#### Federal Motor Vehicle Safety Standards; Occupant Crash Protection

**ACTION:** Correcting amendment.

**SUMMARY:** This rule corrects an error in the figure for the removable dash label

Figure 12. Removable Label on Dash.

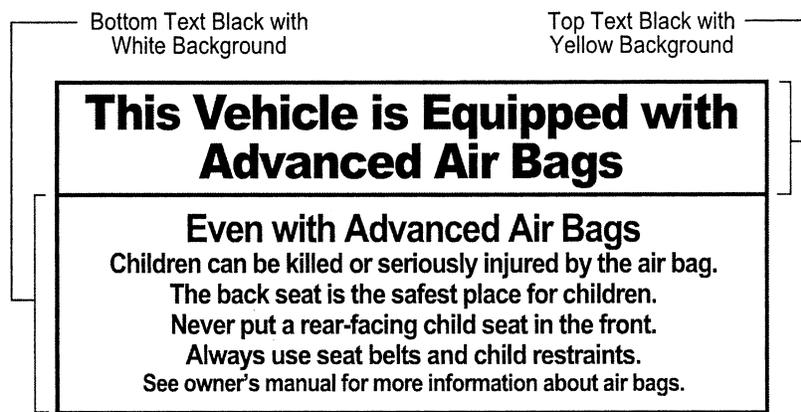
required under Federal Motor Vehicle Safety Standard (FMVSS) No. 208, *Occupant Cash Protection*. This document resolves the problem by adding Figure 12, in order to restore consistency between the advanced air bag removable dash label and the advanced air bag sun visor warning label. This document also corrects a cross reference to the definition of "carlines" contained in the limited line manufacturer exception to the advanced air bag phase-in requirements.

However, the inclusion of the statement in the sun visor label, but not the dash label, created an inconsistency between the labels. Prior to the January 2003 amendment, the advanced air bag sun visor label (FMVSS No. 208, Figure 8) and the current advanced air bag dash label (FMVSS No. 208, Figure 9) were

In response to the January 2003 final rule, Honda commented that, "the Removable Label on Dash (Figure 9) that should correspond to the applicable sun visor label was not amended. To avoid confusing or misleading users, the statement '*never put a rear-facing child seat in the front*' should be added in the removable label." The agency agrees that the warnings on the removable dash label and sun visor label should be consistent.

To maintain consistency and conform the dash label to the sun visor label, Figure 12 is added to FMVSS No. 208, which is identical to Figure 9 except that Figure 12 has an additional bullet point stating: "Never put a rear-facing child seat in the front." Maintaining the uniformity of the dash and sun visor labels ensures that users are not confused as to the importance of placing rear-facing child seats in the vehicle's back seat. To further maintain consistency with the sun visor label, the bullet point will not be required on the temporary dash label if the vehicle has no back seat or the back seat is too small to accommodate a rear-facing child restraint.

The removable dash labels required on vehicles certified on or after December 1, 2003, must conform to Figure 12 of FMVSS No. 208. The labels on vehicles certified before December 1, 2003, must conform to either Figure 9 or 12.

(iv) If the vehicle does not have a back seat or the back seat is too small to accommodate a rear-facing child restraint consistent with S4.5.4.1, the label shown in Figure 12 may be modified by omitting the statement: "Never put a rear-facing child seat in the front."

(iv) If the vehicle does not have a back seat or the back seat is too small to accommodate a rear-facing child restraint consistent with S4.5.4.1, the label shown in Figure 12 may be modified by omitting the statement: "Never put a rear-facing child seat in the front."
